Supplemental Safety Evaluation  
For The  
General Electric Topical Report  
Qualification Of The One-Dimensional  
Core Transient Model For  
Boiling Water Reactors  
NEED-24154 and NEDE-24154P  
Volumes I, II and III

Reactor Systems Branch, DSI

Figure 2-1. 5% Significance Coefficient (A) vs. Surveillance Data in Cycle

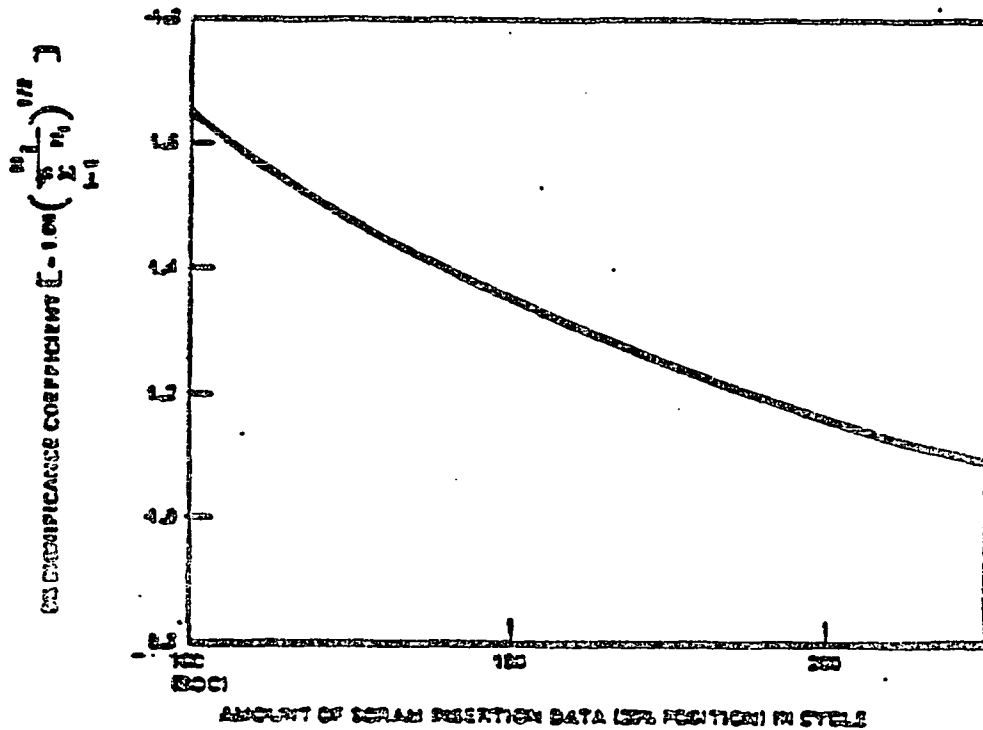
The relationship between the coefficient, A, and the amount of surveillance data generated during the cycle is illustrated in Figure 2-1. As more data become available through the performance of in-cycle surveillance tests, the coefficient decreases, as does the acceptance criterion,  $\tau_2$ . Thus, the screen speed criterion is being tightened as the cycle progresses, based on the assumption that, as more screen data become available during the cycle, the uncertainty in the mean value estimation should decrease.

We find the screen insertion time conformance procedure to be acceptable.
